LTR-NRC-15-33 NP-Attachment

**WCAP-17721-P NRC Set 2, Safety and Code Review Branch –
RAI 2.32 Response Supplement (Non-Proprietary)**

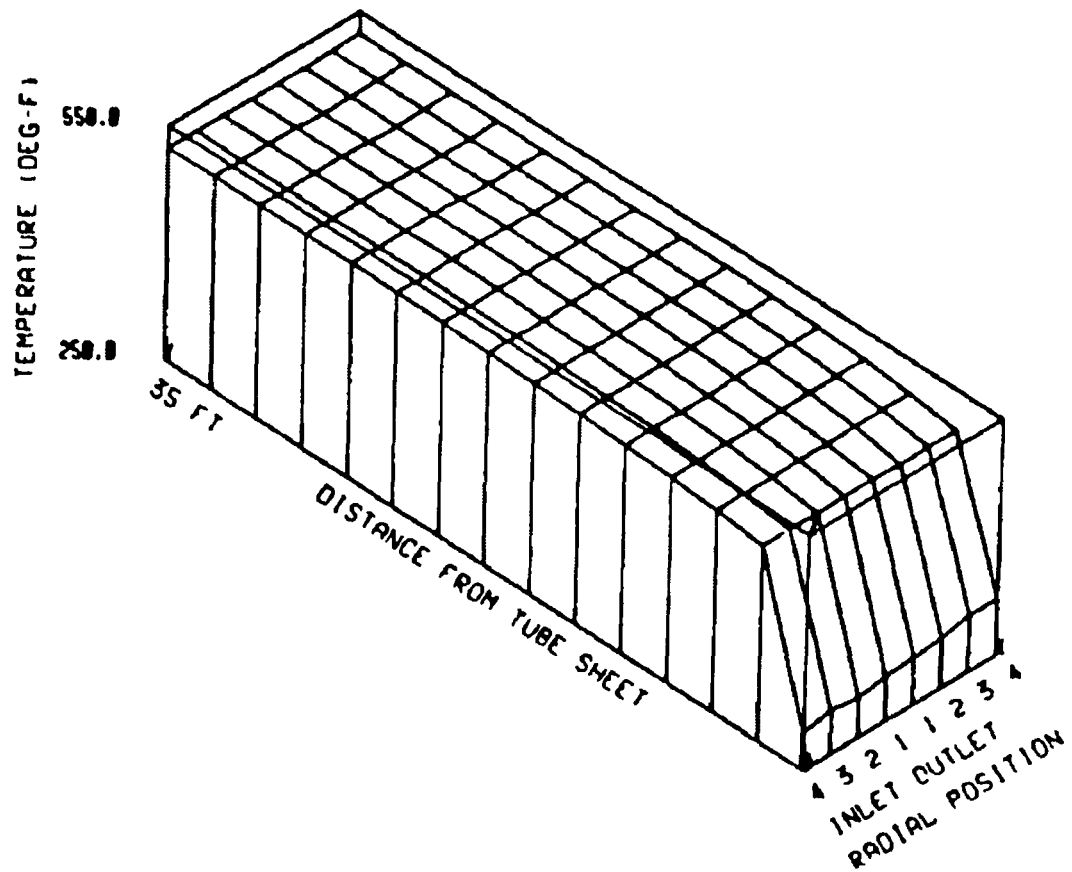
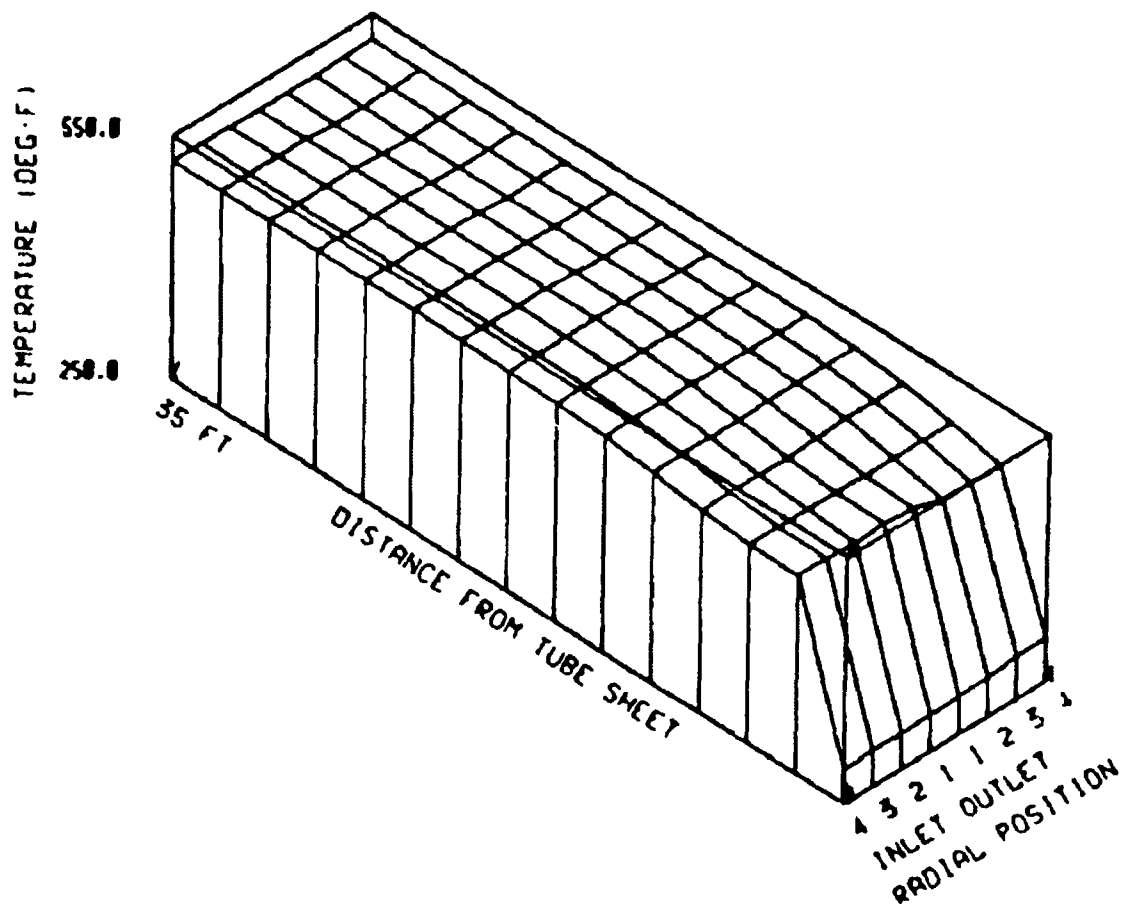
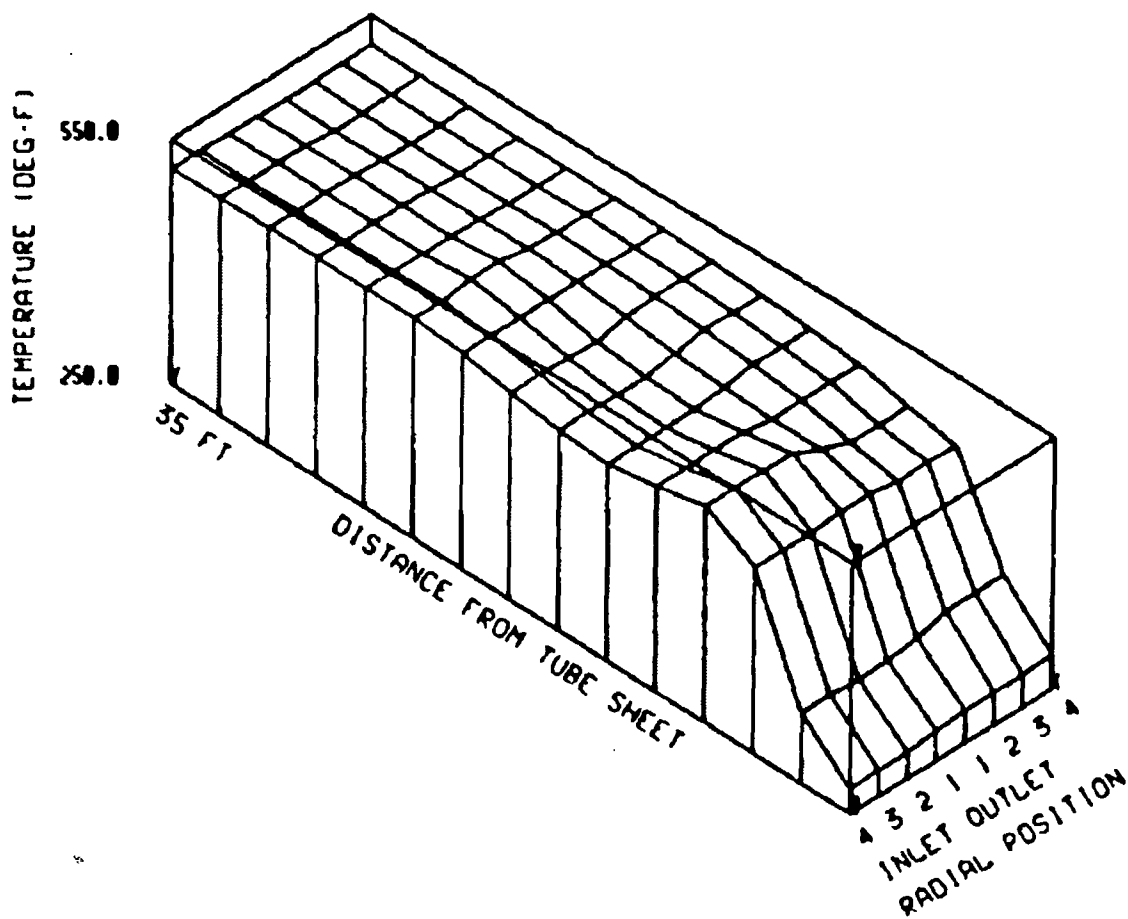
Westinghouse's argument that the WCT FLECHT SEASET SG simulations provided conservative results relative to secondary to primary heat transfer was primarily based on the []^{a,c}. WCAP-9724 (NUREG/CR-1534)³ contains isometric plots which show radial secondary side temperatures vs elevation above the tube sheet for R22701. Figure 5-46 through Figure 5-48 (reproduced below) indicate that there is []^{a,c} at any given time and elevation. The lack of []^{a,c} can be demonstrated for R22920 and R23402 as well with

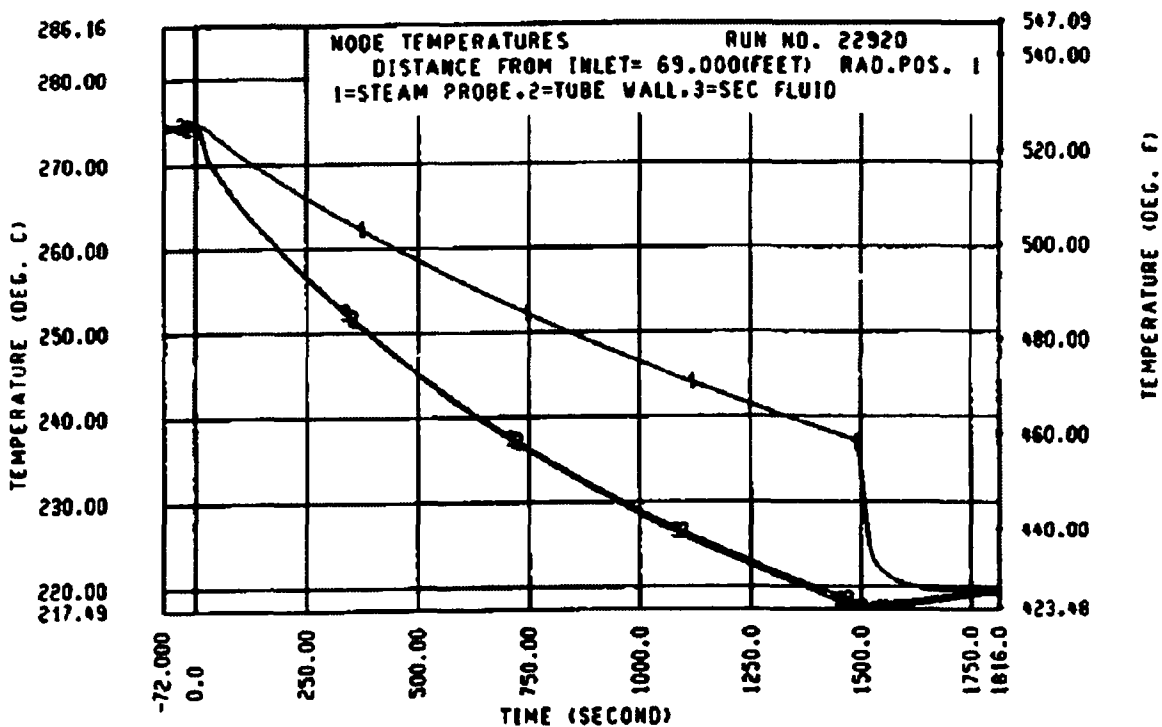
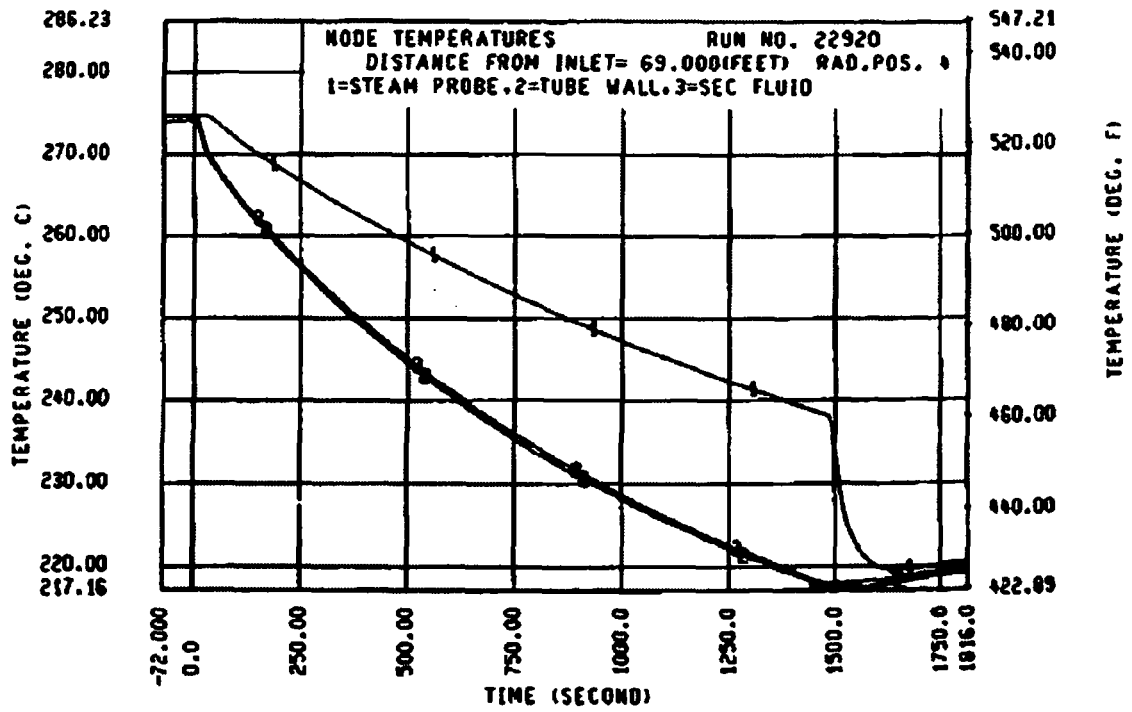
information from WCAP-9621⁴ (detailed data report). Figure 1 and Figure 2 show the secondary fluid temperature at 69 ft from the tube inlet (i.e. near the outlet) for radial positions 1 (close to centerline) and 4 (closest to SG shell) for R22920. The temperature profiles for radial positions 1 and 4 []^{a,c}. Figure 3 and Figure 4 show the same comparison for R23402. This indicates that the SG was cooling down []^{a,c}.

Figure 5: R22920 Primary Side Inlet Temperature

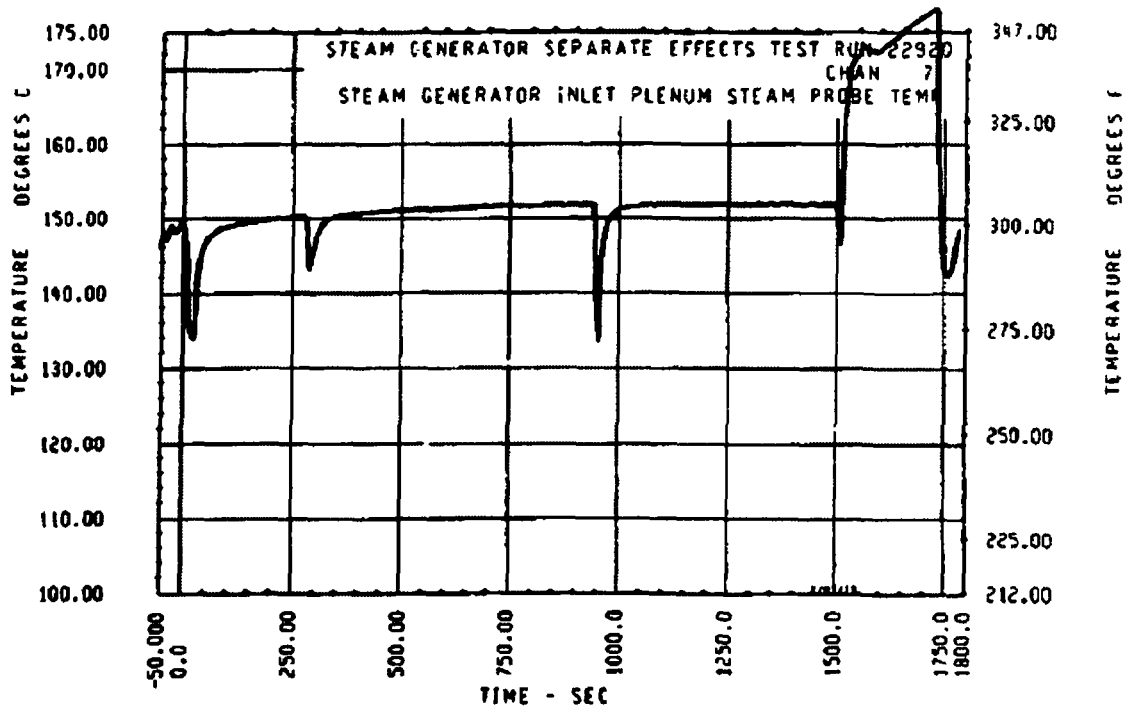
The summary data on page 22920-1 of WCAP-9621 for R22920 indicates that the temperature of the steam flow was 157°C, which was modeled in WCT; however, the plot showing the SG inlet temperature on page 22920-7 (copied below as Figure 5) shows the SG inlet temperature []^{a,c} There is also a flow transient shown on page 22920-4 (copied below as Figure 6). The R22920 case was re-run with WCT accounting for the aforementioned items. The WCT calculated integral of the SG energy release is still []
